Stainless Steel Drain with Crumb Cup Strainer

SUBMITTAL IDENTIFICATION SHEET

WEBSTER UNIVERSITY ISB
PROJECT NAME

123553-001 REV 2
CONTRACTOR / CM SUBMITTAL NO.

J-35

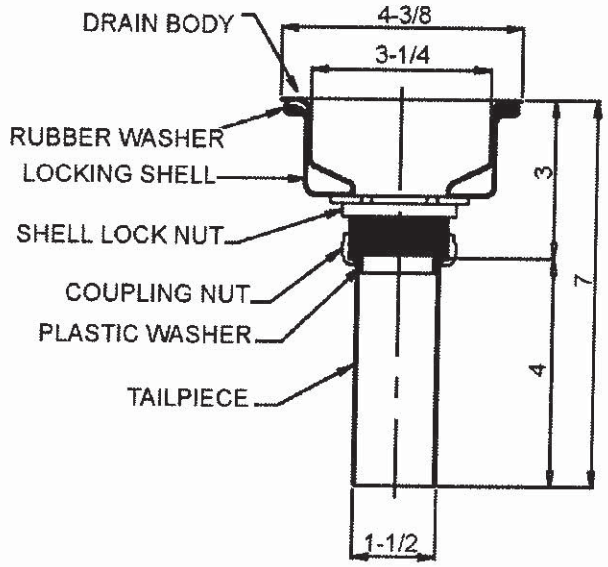
COORDINATE WITH PLUMBING DOCUMENTS.

PLUMBING TO REVIEW
